Architectural Review Board Staff Report

Meeting Date: April 4, 2024
Report #: 2403-2758

2501 Embarcadero Way [22PLN-00367]: Recommendation to Council for Approval of a Site and Design Application and a Design Enhancement Exception to Allow the Construction of a Local Advanced Water Purification System at the Regional Water Quality Control Plant (RWQCP). A Design Enhancement Exception to Allow for a Taller Screening Wall is Also Requested. Environmental Assessment: Council Previously Adopted an Addendum to the 2015 Environmental Impact Report (EIR) for the City of Palo Alto Recycled Water Project Which Evaluated the Environmental Impacts of the Proposed Project. Zone District: PF (D) (Public Facility with Site and Design Combining District). For More Information Contact the Project Planner, Claire Raybould, at Claire.Raybould@Cityofpaloalto.org

FIGURE 1. AERIAL VIEW SHOWING EXISTING & NEAR-FUTURE FACILITIES
AWPS LOCATED ON THE LOWER LEFT CORNER (NORTHWEST)

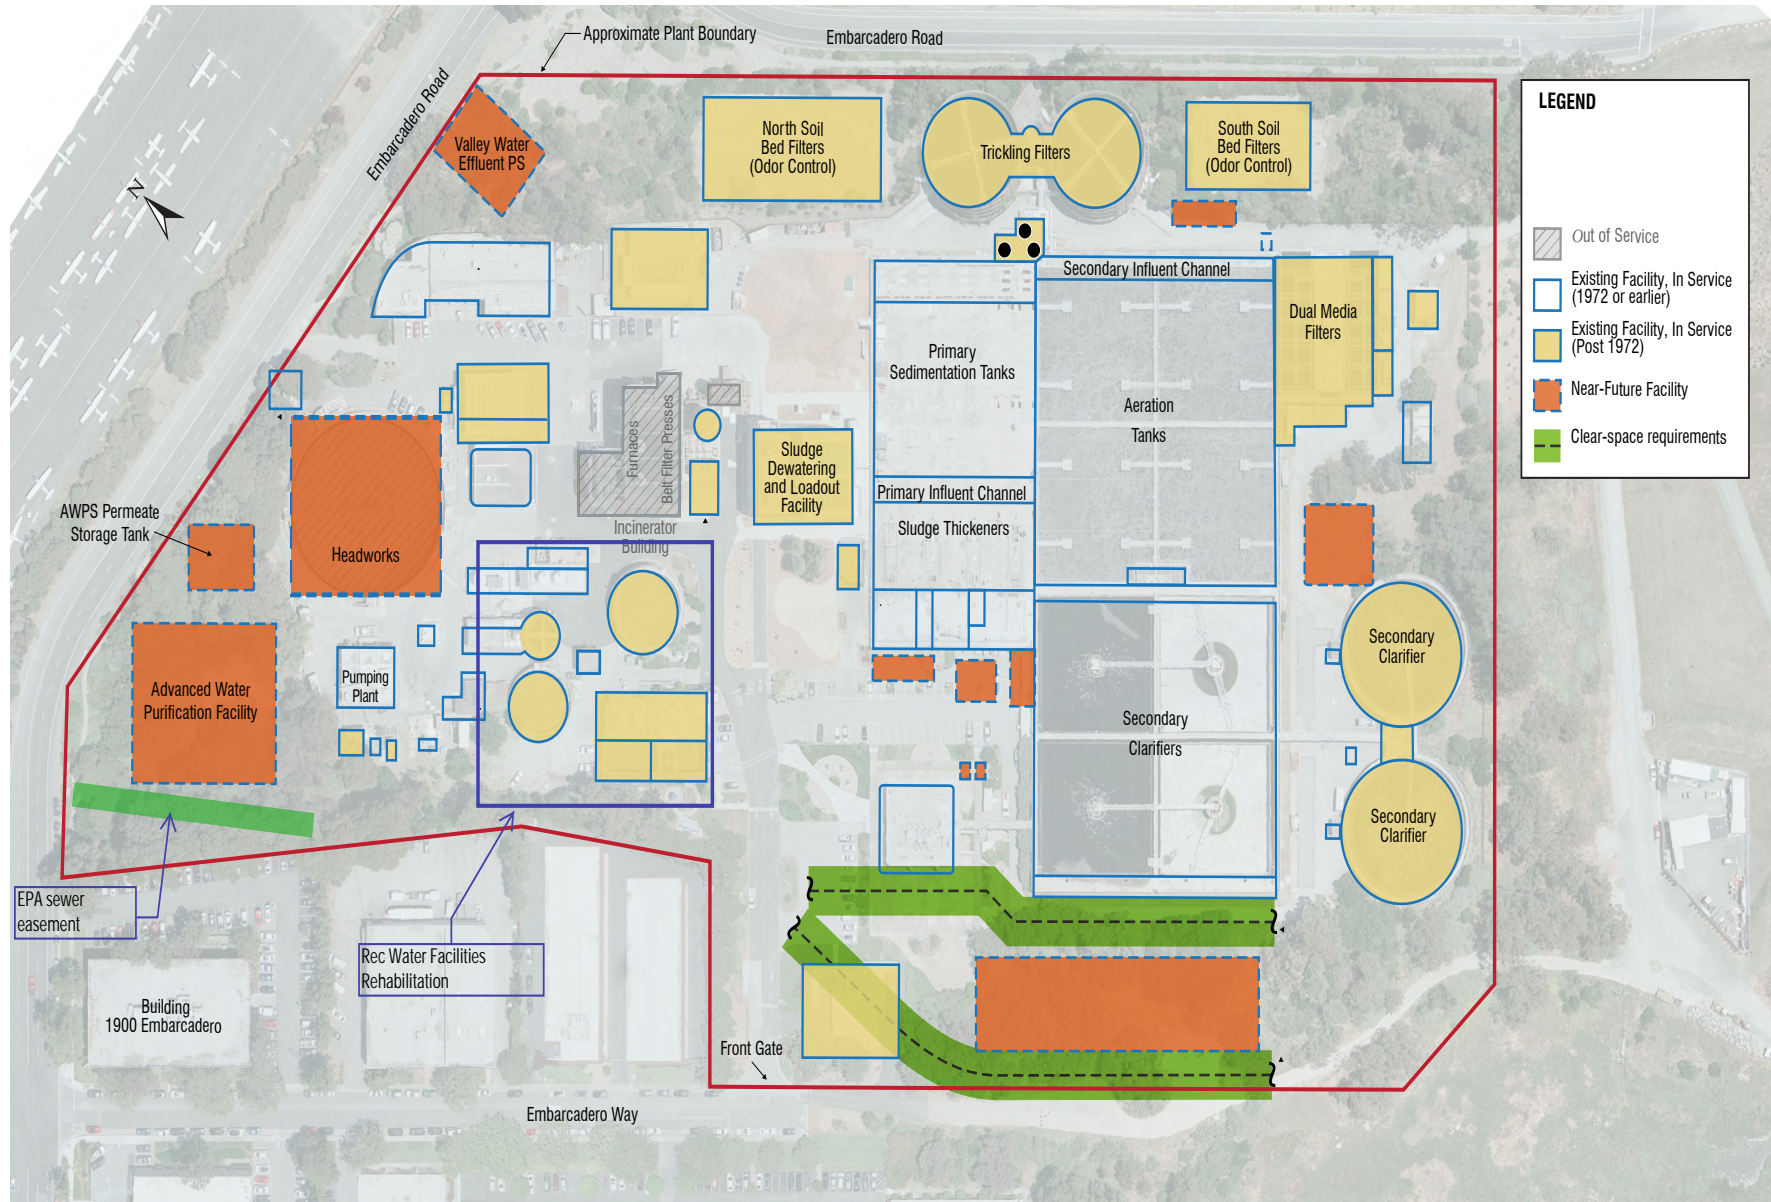
Boardmembers asked for a more complete picture of the RWQCP to provide better context regarding space constraints. Some boardmembers asked for more information to show why the facility can't be moved about 10 feet to the southeast to provide a greater setback from Embarcadero Road.

- Area to the southwest of the AWPS can't be utilized due to a sanitary sewer easement (main line from East Palo Alto)
- Area to the southeast of the AWPS is occupied by the Influent Pumping Plant and Junction Box (where all sewer lines discharge)
- Old Chlorine Contact Tank area is reserved for future Headworks Facility needed to replace aging facilities from 1972

Figure 1. Plan view of AWPS canopy.

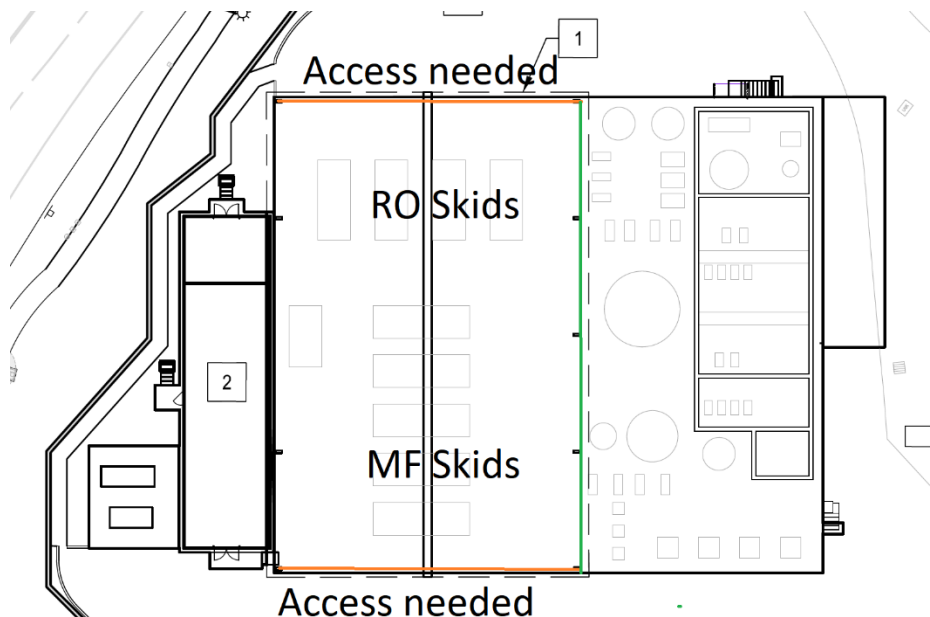
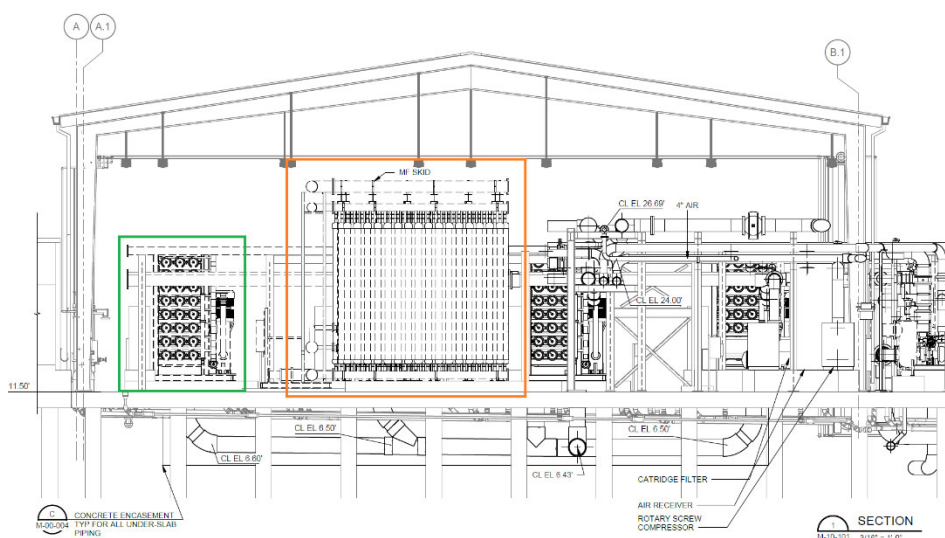
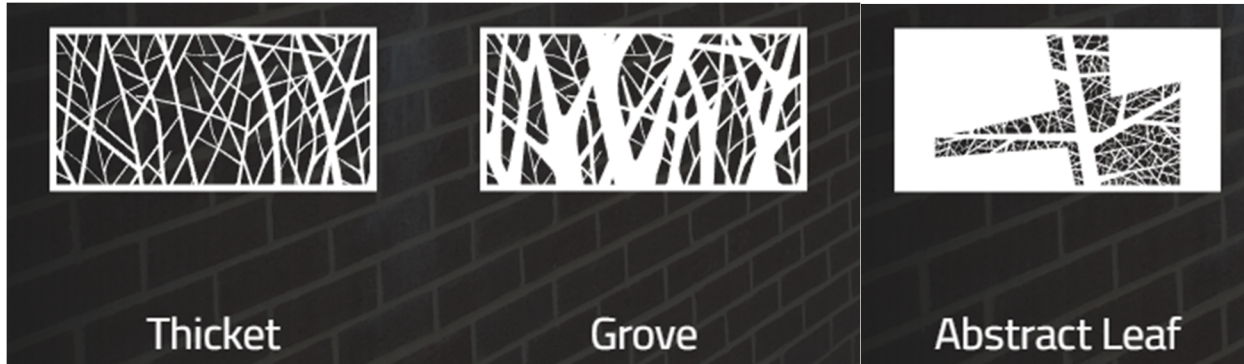
One item for discussion was the possibility of adding screening to the open canopy around the entire building or at least on the side that faces Embarcadero Road (northwest). The City and design team evaluated the feasibility of installing screening on each side of the canopy. For the northeast and southwest faces of the canopy (Figure 1), access is needed to maintain, repair and replace reverse osmosis (RO) and microfiltration (MF) skids. Figure 2 shows sections of the RO skids (green) and MF skids (orange). Full height access will be required during operations; therefore, it is not possible to add screening in these faces. The southeast face of the canopy, shown in green (Figure 1), is located towards the interior of the Regional Water Quality Control Plant (RWQCP), therefore no screening will be provided. Additionally, open access is needed to allow crews remove and replace equipment.

The City and design team evaluated a few options to provide screening to the northwest face of the AWPS canopy. Canopy coverings cannot be installed from the floor to the bottom because access is needed. Canopy screening could be installed from the canopy line down to the top of the electrical building. One proposal is to use functional metal art screen panels. These panels are perforated screen metal sheets and can be used to secure or obscure mechanical or electrical equipment. These panels come in various sizes and are made of steel, cor-ten steel or aluminum. Colors available are white, black, bronze, dark blue, beige, green, orange, red and silver. From the available patterns, the proposed ones are shown below (Figure 4). A few examples are provided below (Figure 5, 6 and 7).
